STAFF REPORT
KETCHUM PLANNING AND ZONING COMMISSION
REGULAR MEETING OF SEPTEMBER 23, 2025

PROJECT: Sawtooth Serenade

FILE NUMBER: P24-027

APPLICATION: Final Design Review

Revised:	6	7	8	9	10
----------	---	---	---	---	----

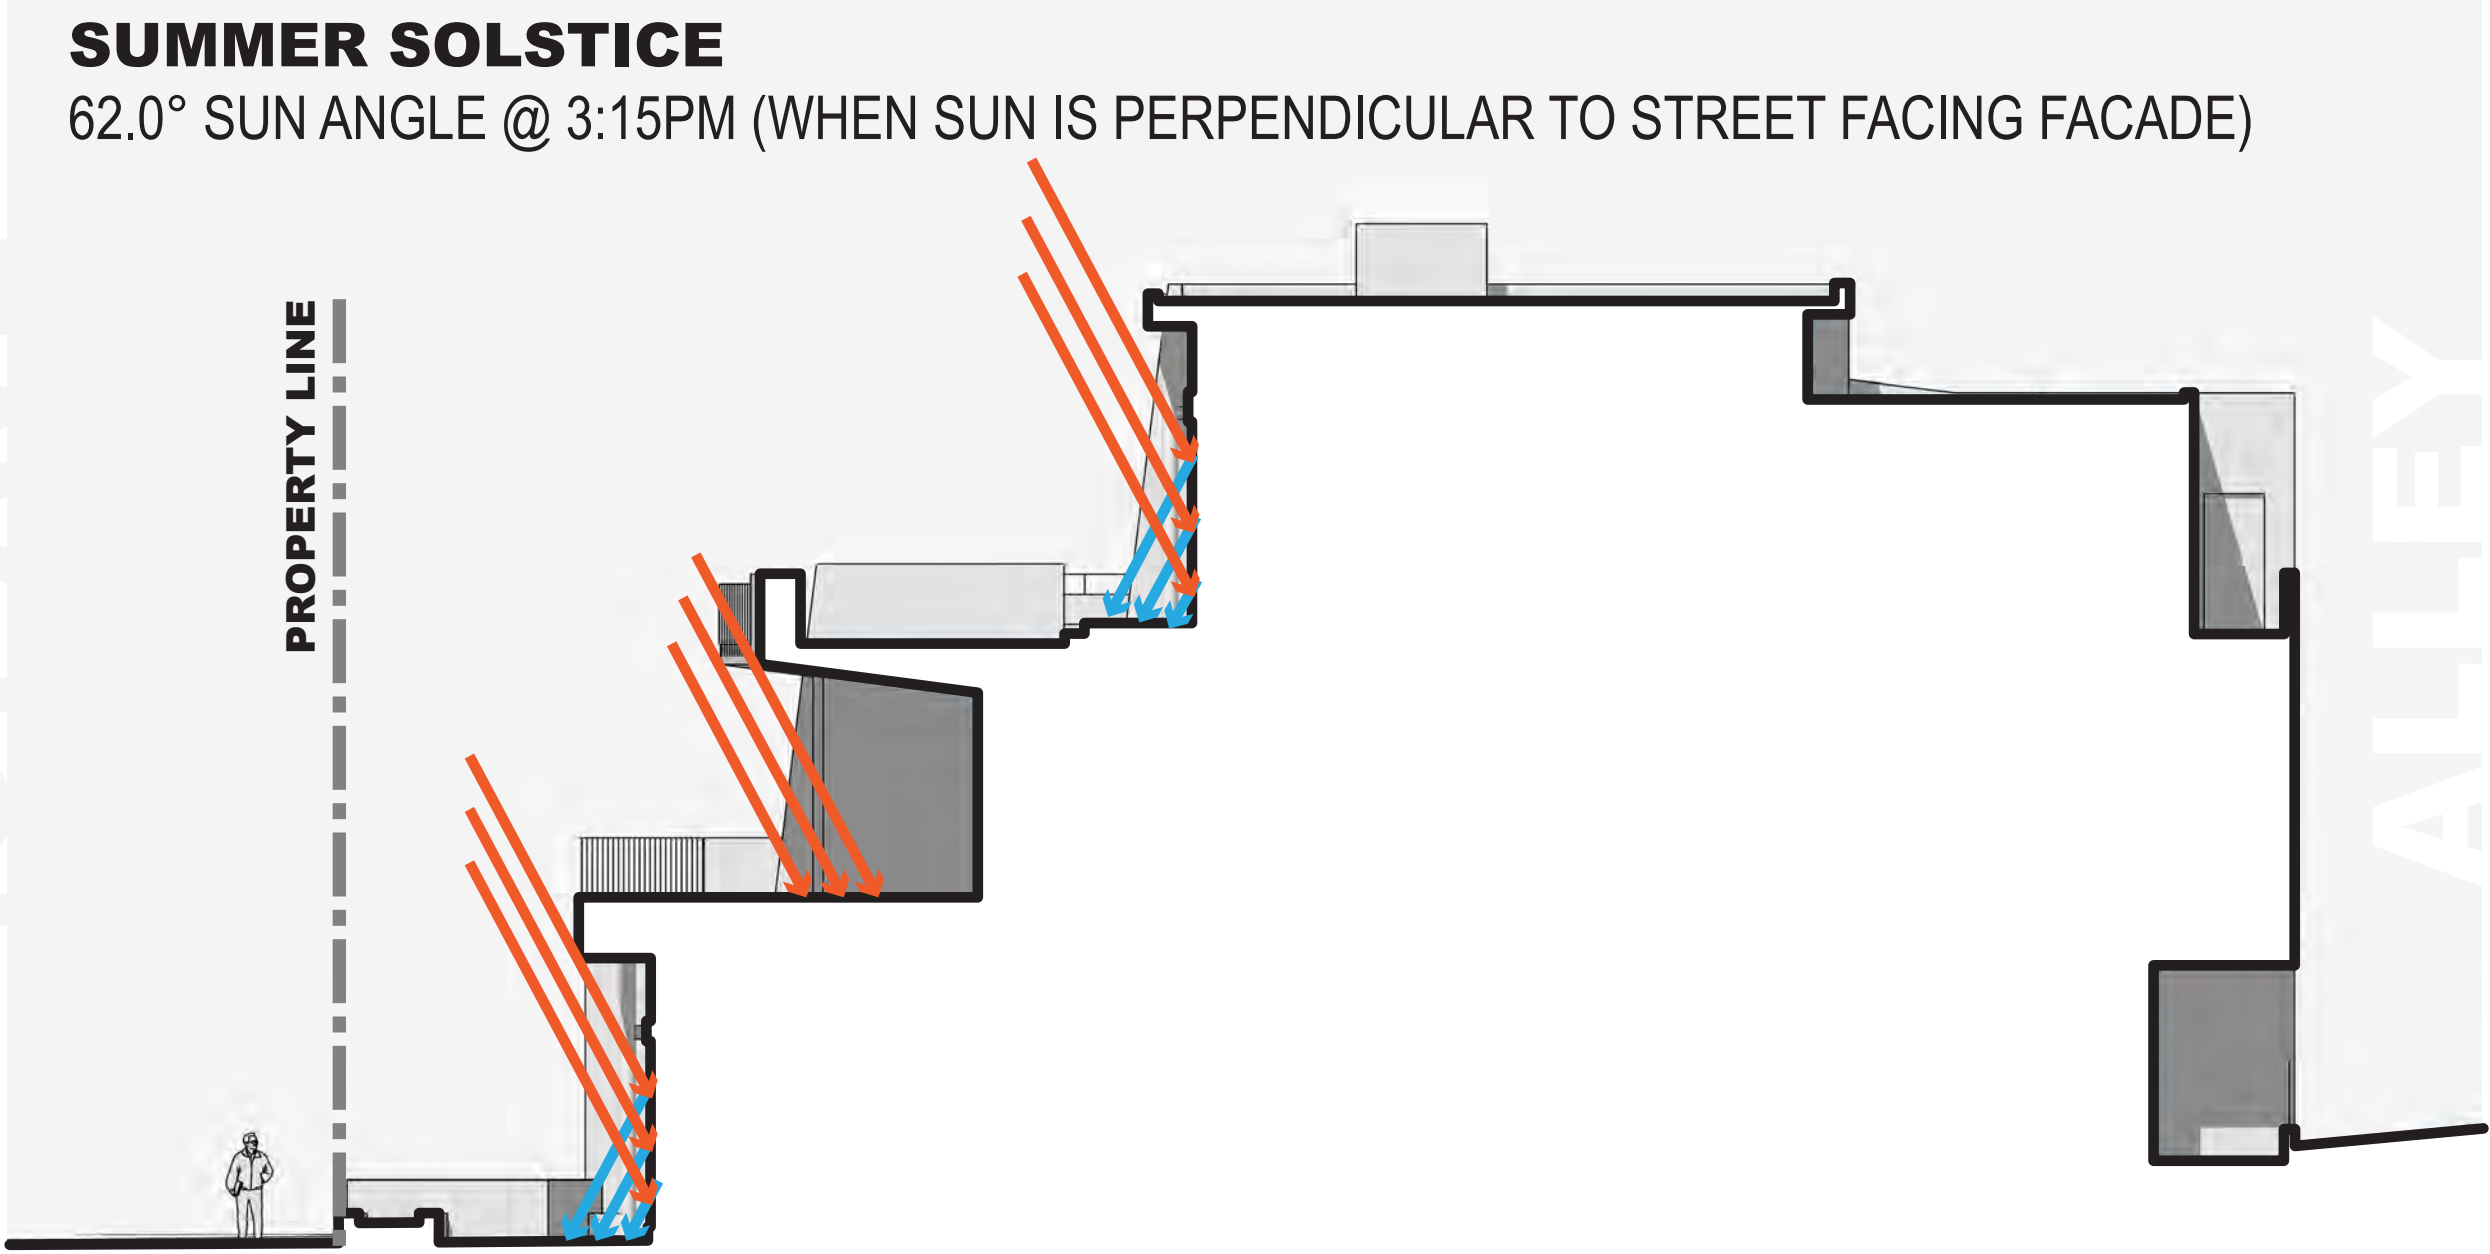
- In one of our coordination meetings with Morgan Landers, she commented that the amount of glazing on 1st Avenue could mean that, at certain times of the day, the sunlight reflecting off the building could be dazzling to people on the street. Because of the cascading nature of the design, the forms of the Lynches’ home and the recessed windows and sunshades of the Berniers’ home, very little reflected sunlight will reach street level. We have done sun studies, and our submittal Sheet A0.14 provides reflected light diagrams showing that only late in the afternoon, in the darkest part of winter, and just before the sun goes behind Baldy, will sunlight reflecting off the building windows reach the public right of way.

During winter months a small fraction of clerestory fenestrations will reflect light into the public right-of-way.

The following diagrams illustrate fenestration reflections at peak times of day. When the sun is perpendicular to the 1st Ave N facade.
